INVITATION TO BID 2026-01
CITY OF PARKER
2025 ROADWAY RESURFACING PROJECT

**ADDENDUM NO. 4
NOTICE TO BIDDERS**

Issued September 29, 2026

**LANCANCE DRIVE IMPROVEMENTS PLAN &
PROFILE**

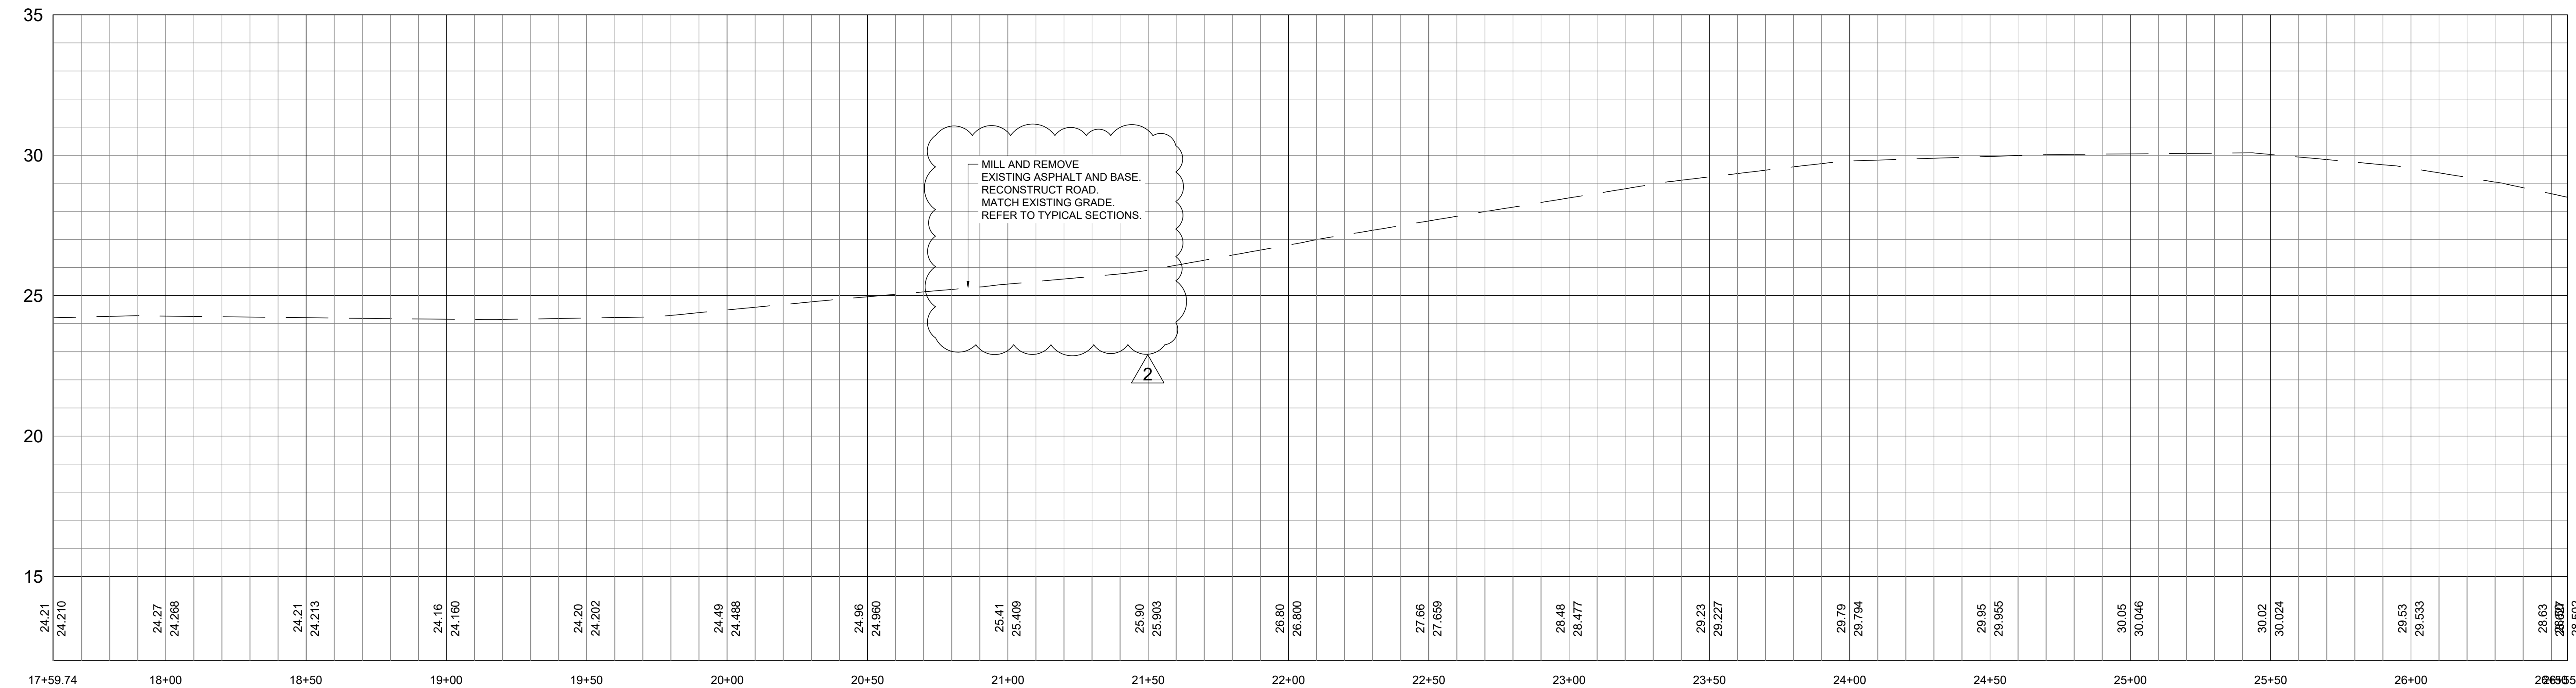
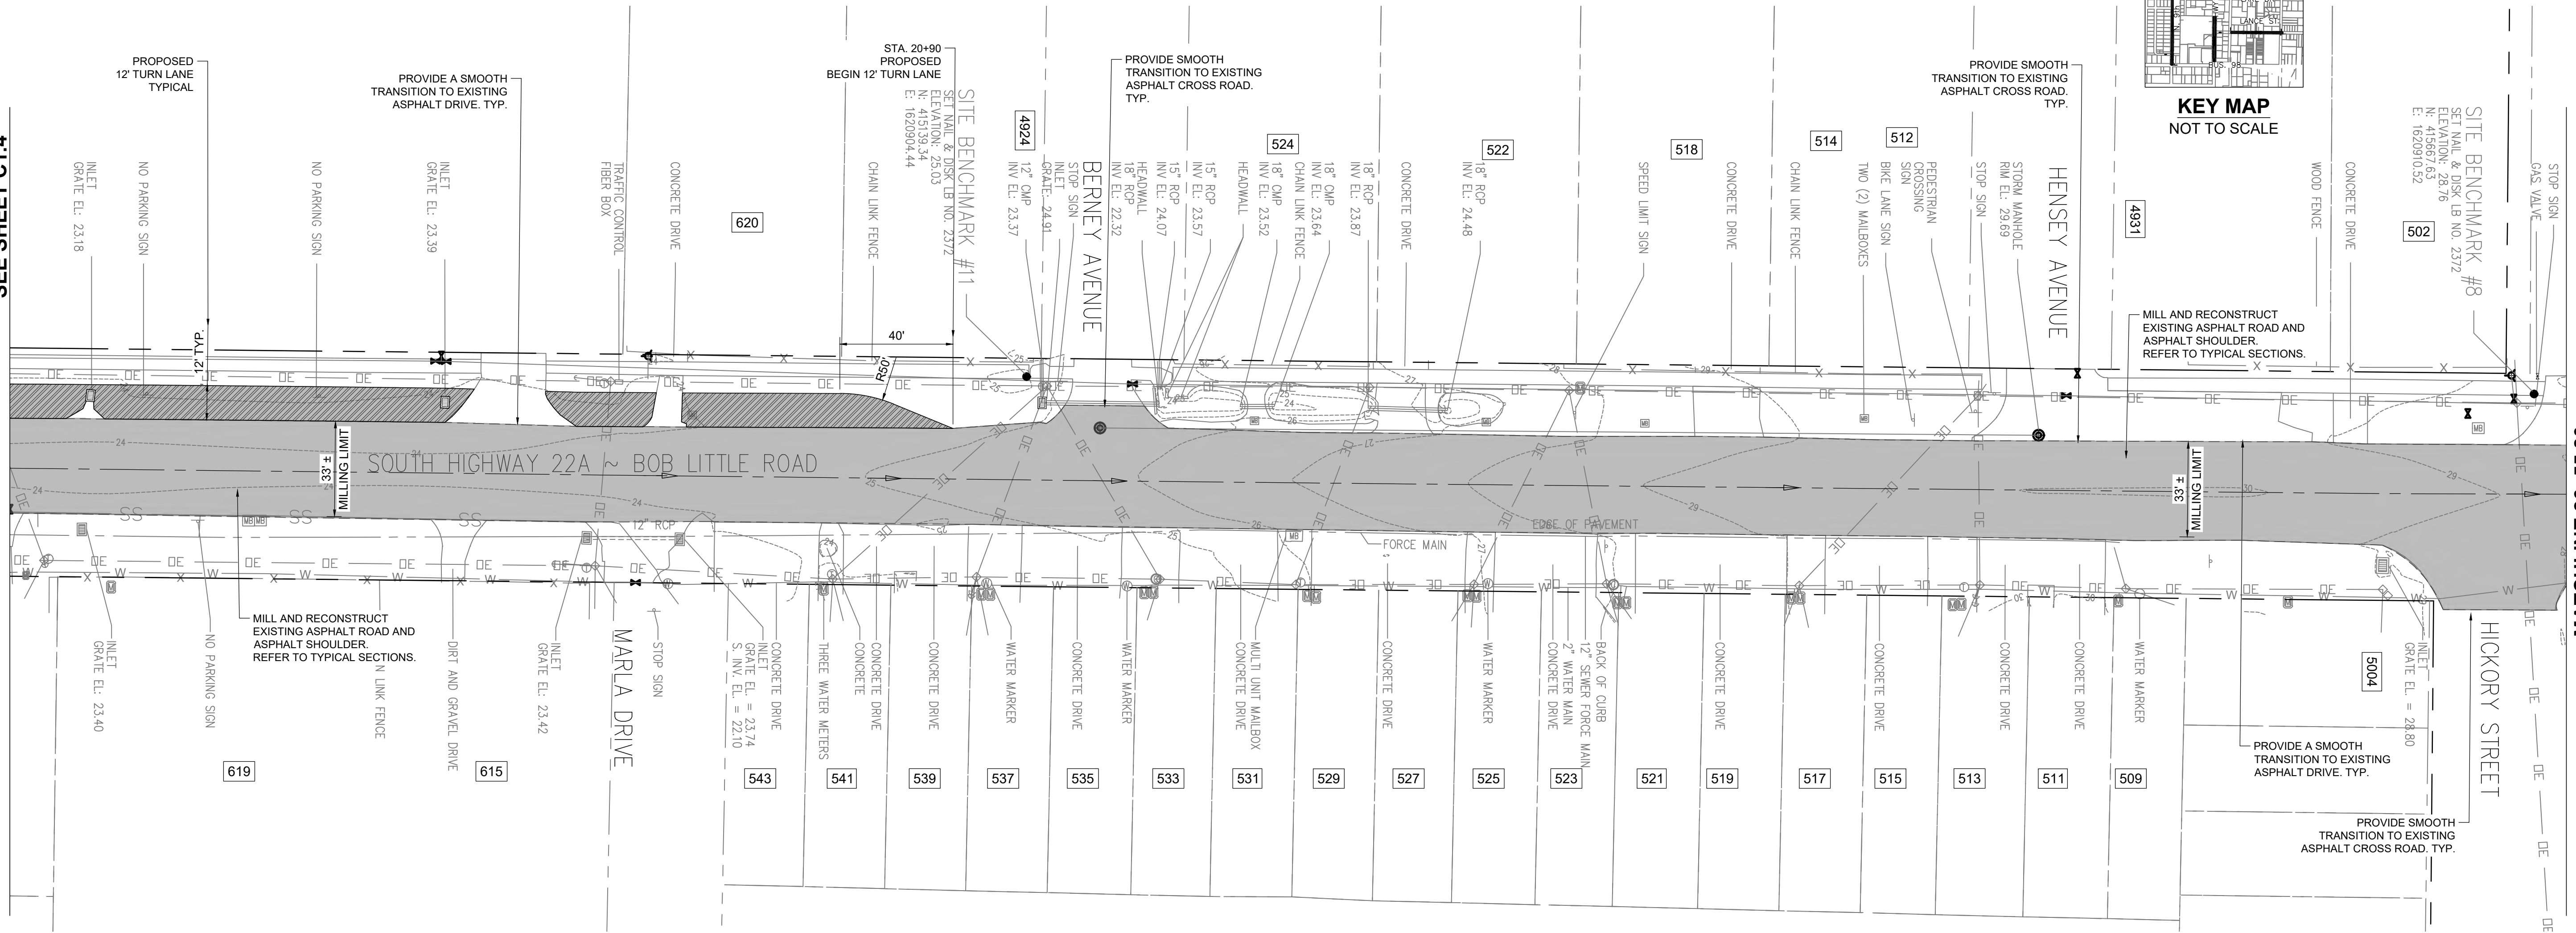
- b. Sheets C1.1 and C1.2 – Lance Drive Improvements Plan & Profile: Note has been **ADDED** to Profiles on both sheets which states, **“MILL AND REMOVE EXISTING ASPHALT AND BASE. RECONSTRUCT ROAD. MATCH EXISTING GRADE. REFER TO TYPICAL SECTIONS.”**

Sheet No.
CI.6

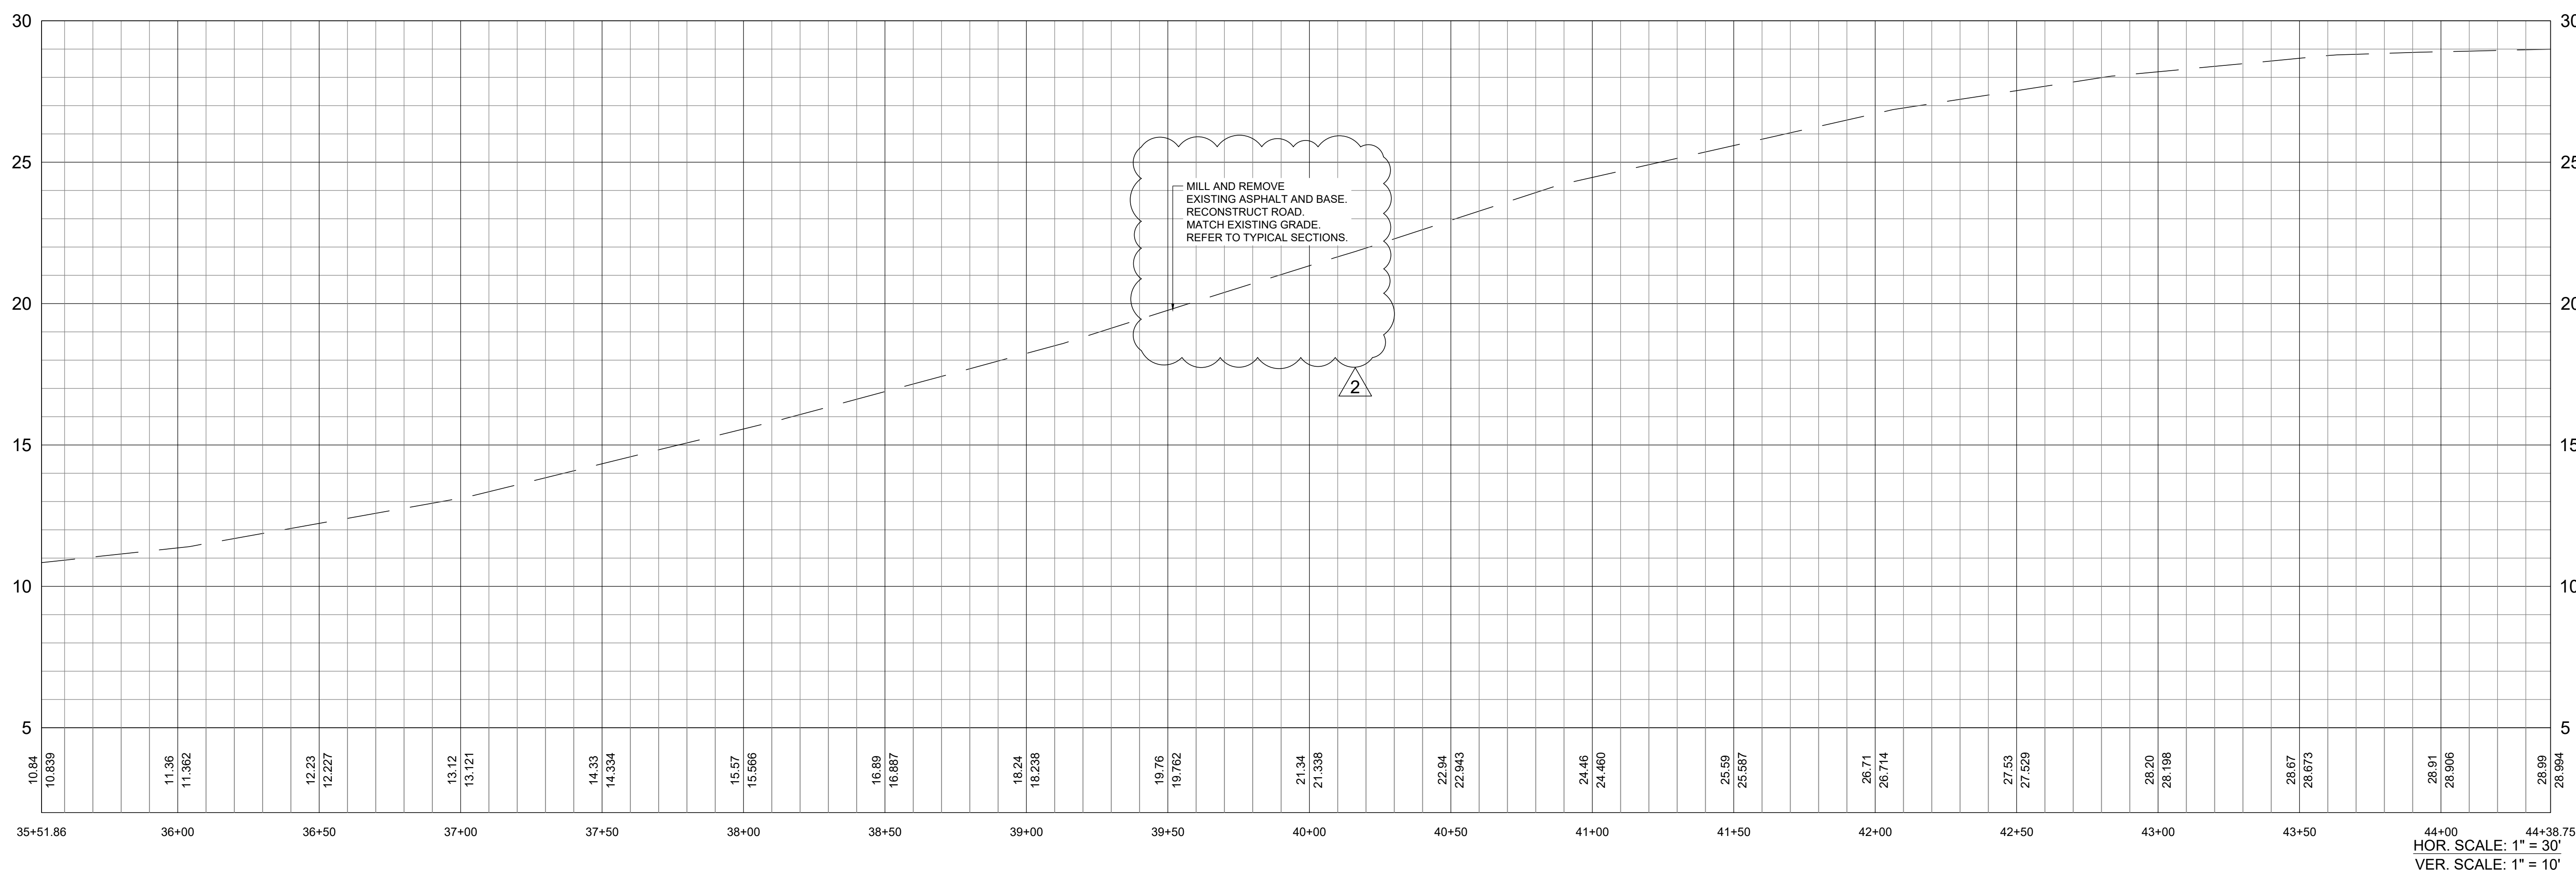
- d. Sheets C1.4 through C1.8 – Hwy 22A (Bob Little Road) Improvements Plan & Profile: Note has been **ADDED** to Profile on each sheet which states, **“MILL AND REMOVE EXISTING ASPHALT AND BASE. RECONSTRUCT ROAD. MATCH EXISTING GRADE. REFER TO TYPICAL SECTIONS.”**

Sheet No.
C2.0

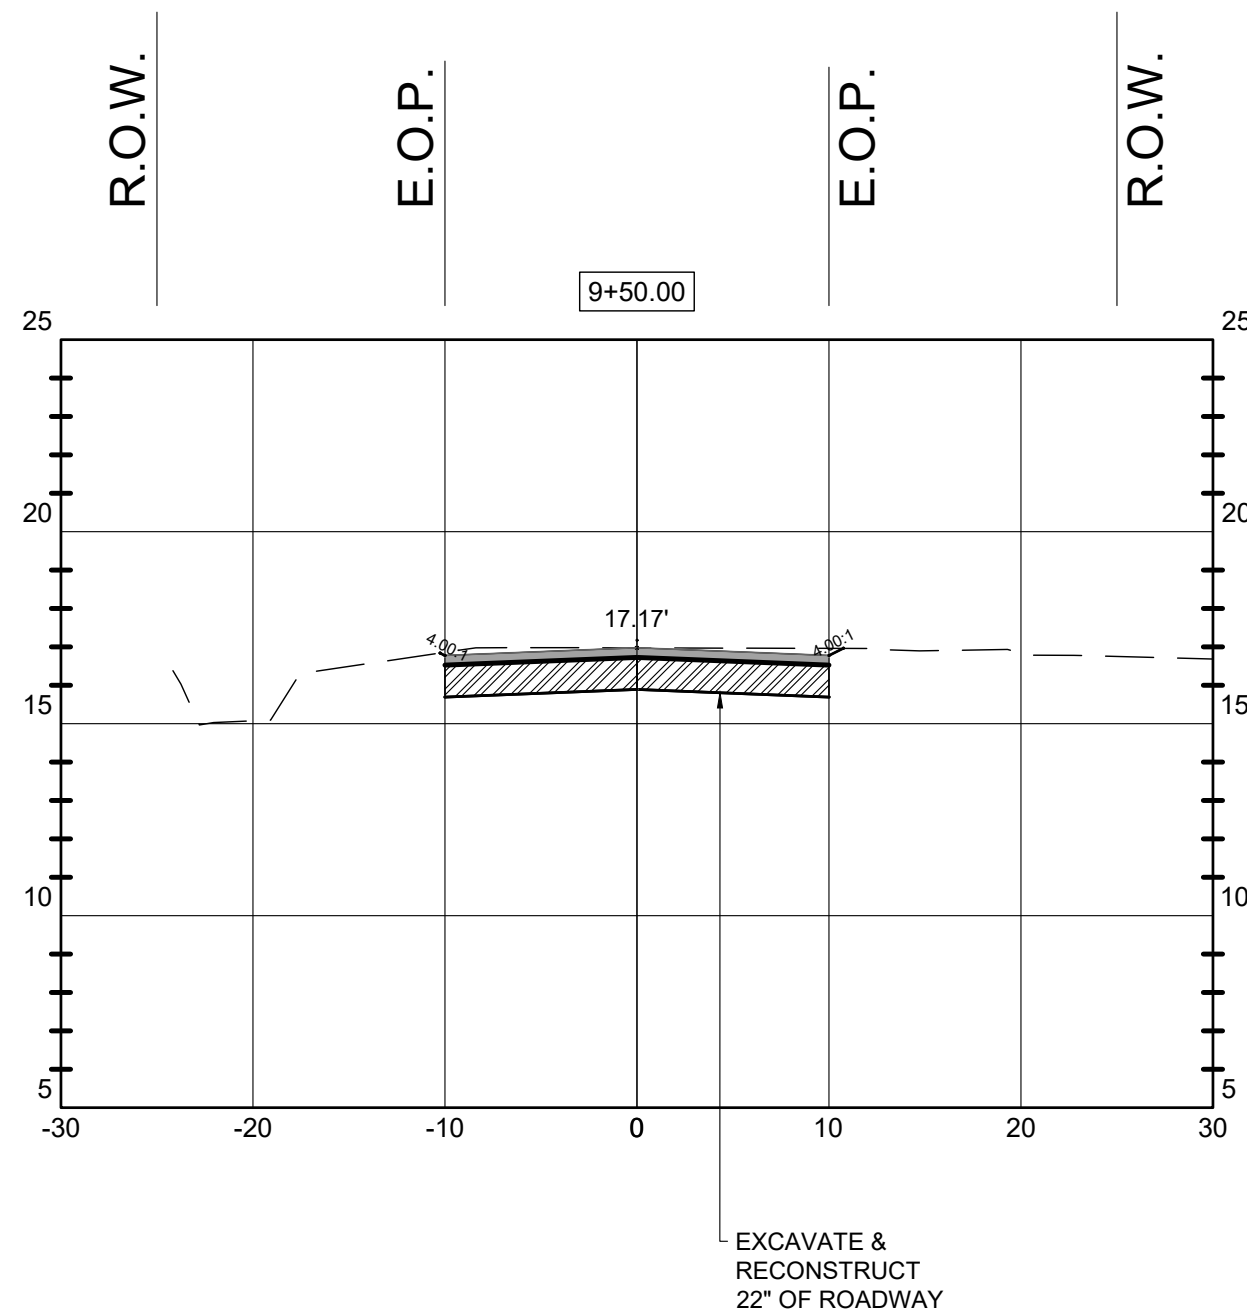
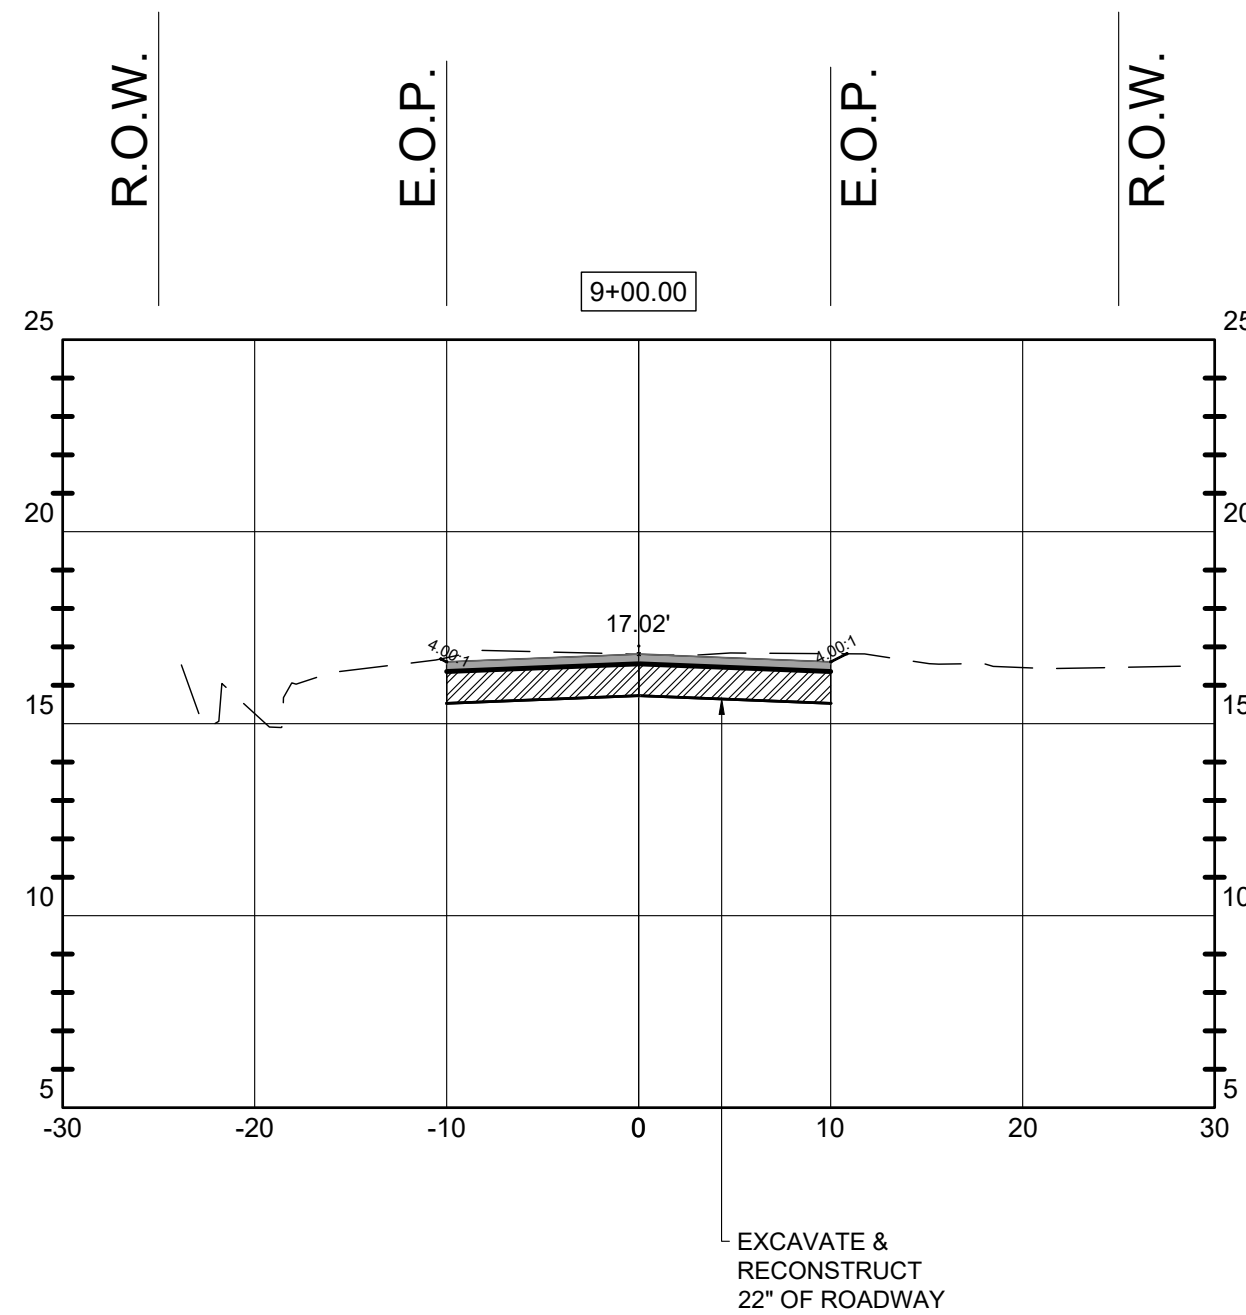
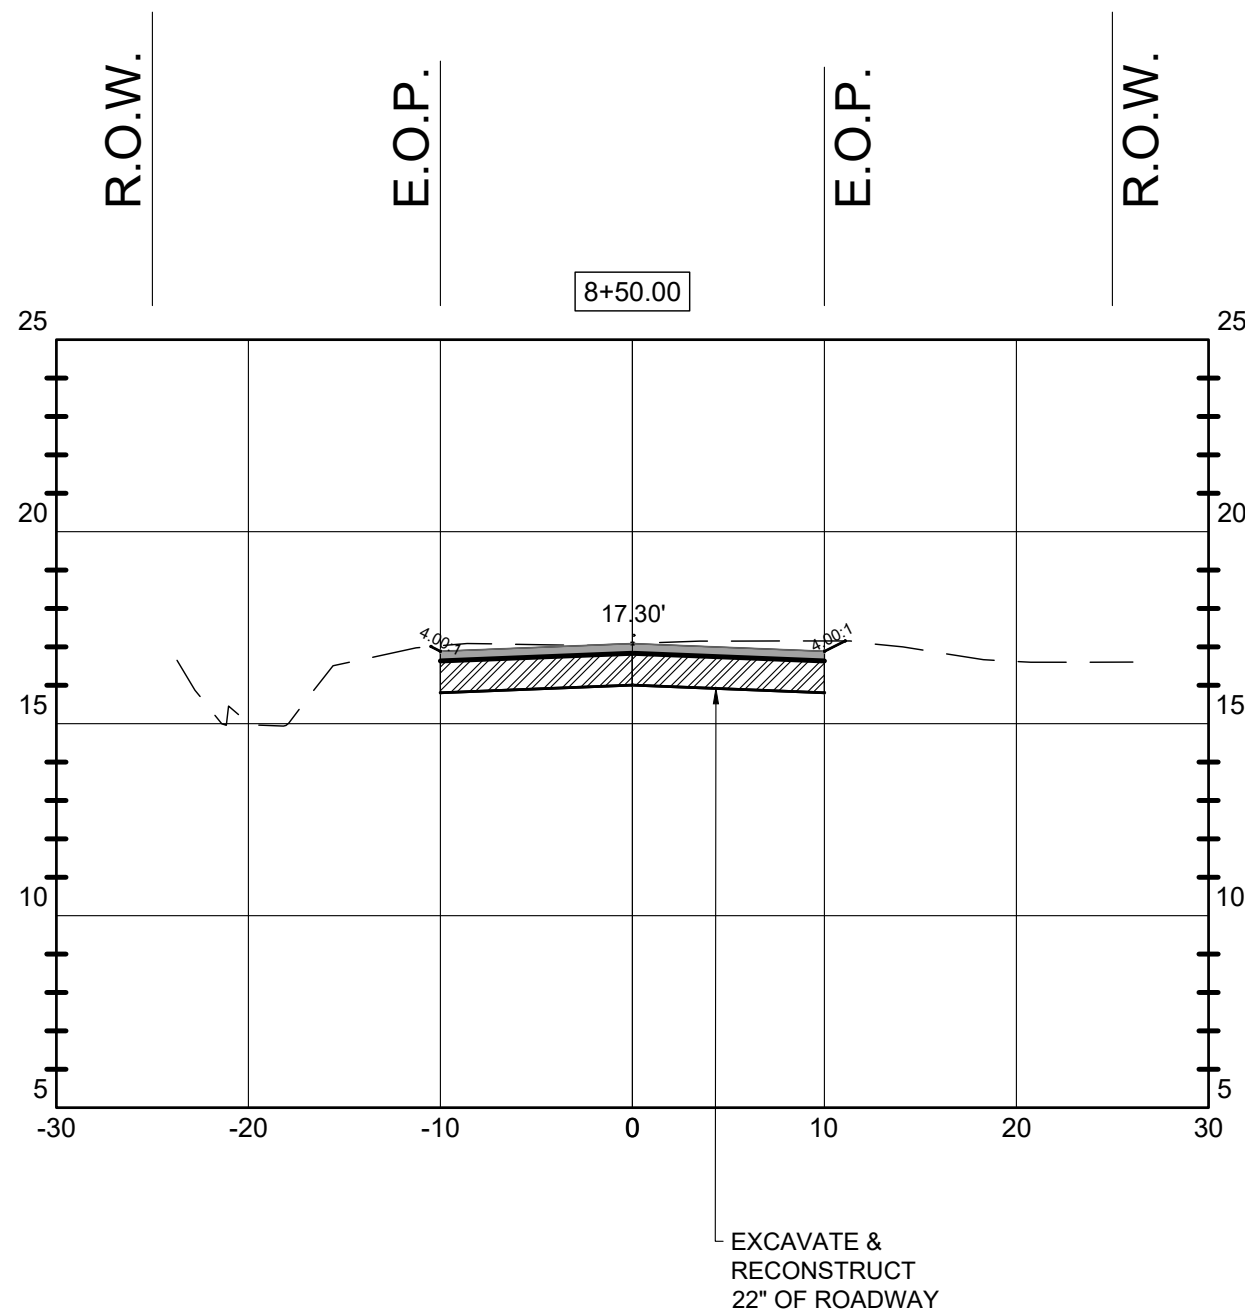
- g. Sheets C2.0 through C2.1 – Lance Street Sections: Sections have been modified within each sheet and a note has been **ADDED** to each sheet which states, **“CONTRACTOR TO ADD COMPACTED FILL ALONG THE EDGE OF THE ROADWAY IF THE DROPOFF IS MORE THAN 1.0” AND SHALL BE PLACED AT A SLOPE OF 1:4 IN ACCORDANCE WITH 2026 OR CURRENT EDITION OF FDOT STANDARD INDEX 570-010.”**

NOTES:
CONTRACTOR TO ADD COMPACTED FILL ALONG THE
EDGE OF THE ROADWAY IF THE DROPOFF IS MORE
THAN 1.0' AND SHALL BE PLACED AT A SLOPE OF 1:4
IN ACCORDANCE WITH 2026 OR CURRENT EDITION
OF FDOT STANDARD INDEX 570-010.
